SpaceWire evolutions and standard revision

SpaceWire standard update (Session 3 part 2.)

1.1 Structure of the document – Change requests

9.5 Update state machine – Change requests

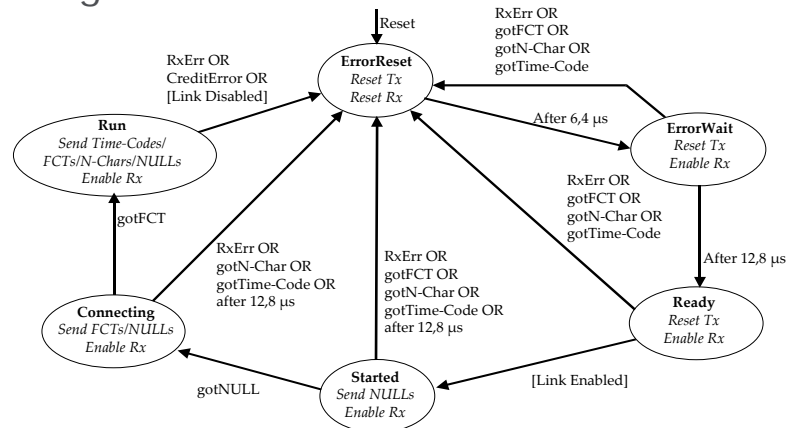
65 [Süss - SpaceWire Standard Evolution - Nov. 2008]	8.5	63	Change state diagram.	During the implementation of the SpaceWire codec some inconsistencies in the transitions described in the state diagram have been identified [10]. a) The transition from Started to ErrorReset is impossible when gotNULL condition is set. b) The transition from Connecting to Run shall be applied only after sending FCT to channel. These inconsistencies will have to be corrected by making some slight modifications of the standard text and state diagrams.
66 [Seynin - SpaceWire Standard Evolution.Seynin.ppt slide 10]	8.5	63	Add requirement "always to send FCT before going to the RUN state"	An only sending node can never set a connection
67 [Isomaki RC4.3]	8.5.2 .7a NOT E		Make the NOTE a requirement instead: 8.5.2.7c The receiver is enabled. 8.5.2.7d The transmitter is enabled to send Time-codes, FCTs, N-Chars and NULLs.	It is not specified in a requirement anywhere in the standard that the transmitter should be enabled to transmit all four character in the run-state. This is only written in descriptive text (and in the state diagram figure which is only referenced from descriptive text).

A shortcoming has been identified in the ECSS-E-ST-50-12C Standard state diagram.

RxErr = Disconnect error OR Parity error OR Escape error (ESC followed by EOP or EEP or ESC).

- **Proposed changes:**
 - Add requirement "always to send FCT before going to the RUN state"
- **Benefits:**
 - Improves SpaceWire state diagram
